Attachment J3

Submissions

Planning Submission
For: SP 67057: 23 Billyard Avenue, Elizabeth Bay

Development Application ('DA') No. 2023/0727
'Demolition of existing buildings, tree removal, excavation and construction of two new residential flat buildings, 6 to 8 storeys in height, with 22 apartments, 4 basement levels containing 27 car spaces, rooftop terraces, swimming pools and associated landscaping works including new tree plantings. The application is Integrated Development requiring the approval of Water NSW under the Water Management Act, 2000.'

1.15pm Proposed

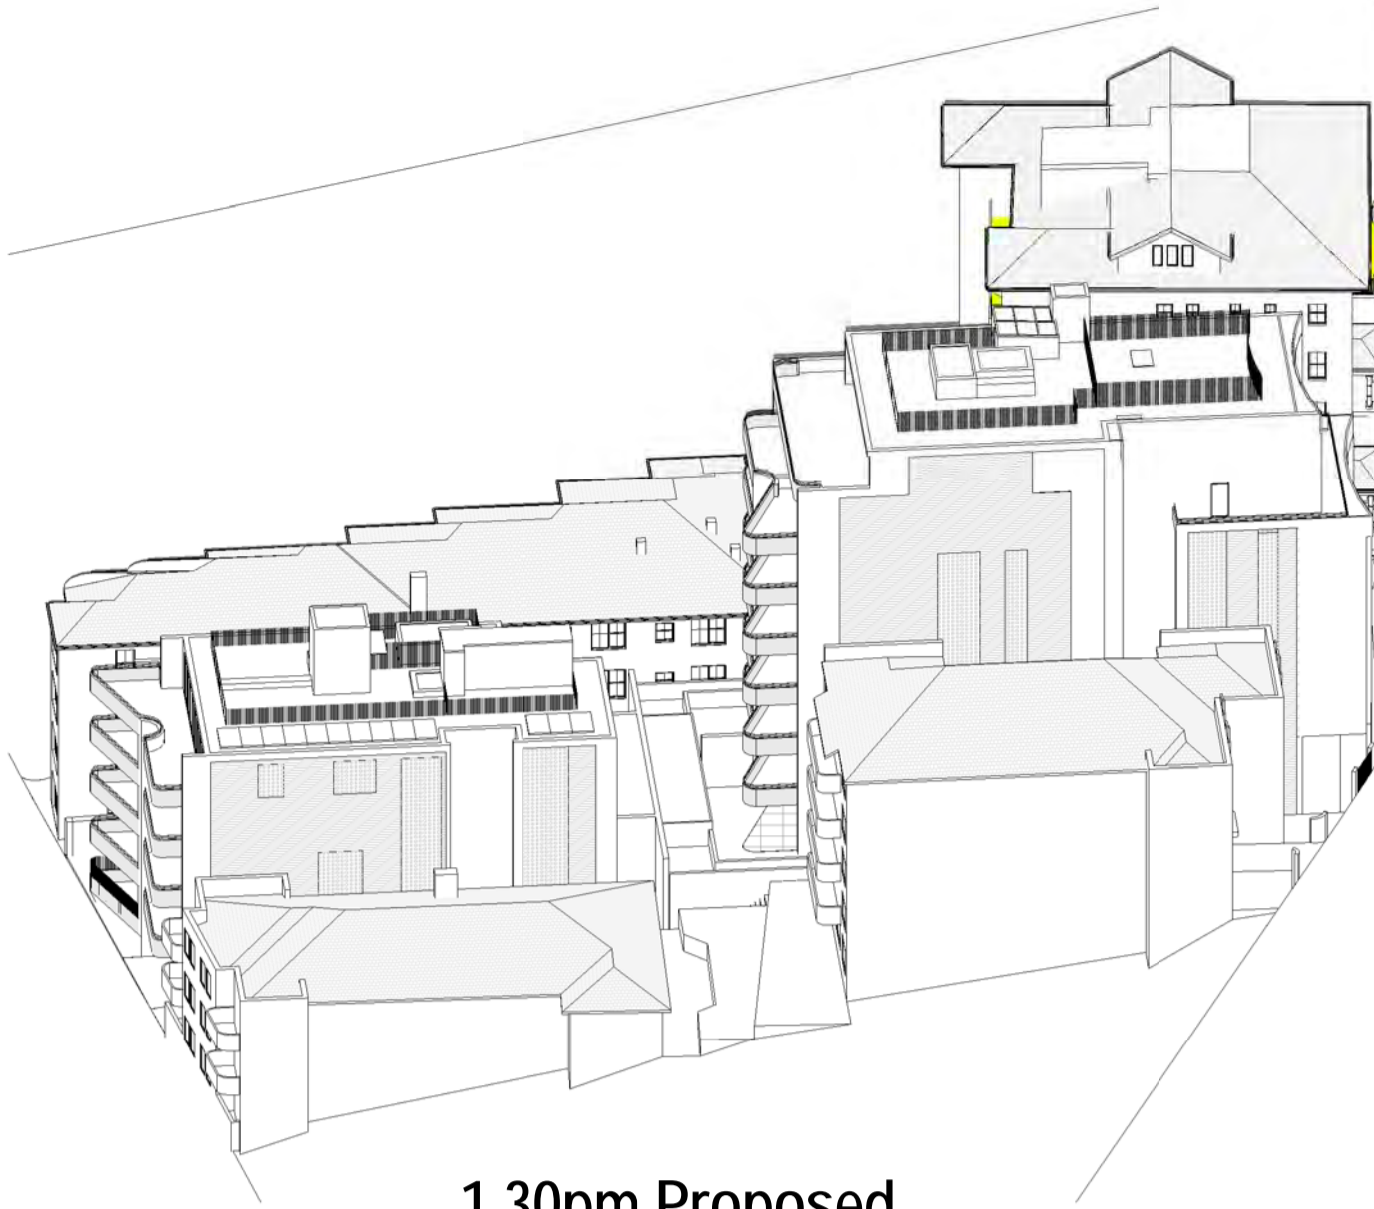
The solar diagrams show worsening of solar access to these only areas of living space (no balconies available). It is noted that staff requested 15 minute intervals and these have not been provided for 23 Billyard Avenue.

1.30	1.45	2.00	2.15	2.30	2.45	3.00	
UNIT 6 LIV	X	X	X	X	X	X	X	
UNIT 7 LIV	X	X	X	X	X	X	X	
UNIT 1 LIV	•	•	•	•	•	•	•	
UNIT 17 LIV	X	X	X	X	X	X	X	
UNIT 18 LIV	•	•	•	•	•	X	X	
UNIT 11 LIV	•	•	•	•	•	•	•	
UNIT 26 LIV	•	•	•	X	X	X	X	
UNIT 27 LIV	•	•	•	•	•	•	•	
UNIT 21 LIV	•	•	•	•	•	•	•	
TOTAL HOURS WINDOWS SOLAR ACCESS JUNE 21ST:								
9.00AM - 3.00PM								
	EXISTING:	PROPOSED:	ACCESS LOST:	% LOST:				
UNIT 6 LIV	0 HOURS	0 HOURS	0	0%				
UNIT 7 LIV	0.25 HOURS	0 HOURS	-0.25 HOURS	100%				
UNIT 1 LIV	6.0 HOURS	2.0 HOURS	-4.0 HOURS	66%				
UNIT 17 LIV	3.25 HOURS	2.25 HOURS	-1.0 HOUR	30%				
UNIT 18 LIV	1.5 HOURS	1.25 HOURS	-0.25 HOURS	16%				
UNIT 11 LIV	6.0 HOURS	2.0 HOURS	-4.0 HOURS	66%				
UNIT 26 LIV	4.25 HOURS	5 HOURS	+0.75 HOURS	+17%				
UNIT 27 LIV	6.0 HOURS	6.0 HOURS	0	0%				
UNIT 21 LIV	6.0 HOURS	3.5 HOURS	-2.5 HOURS	42%
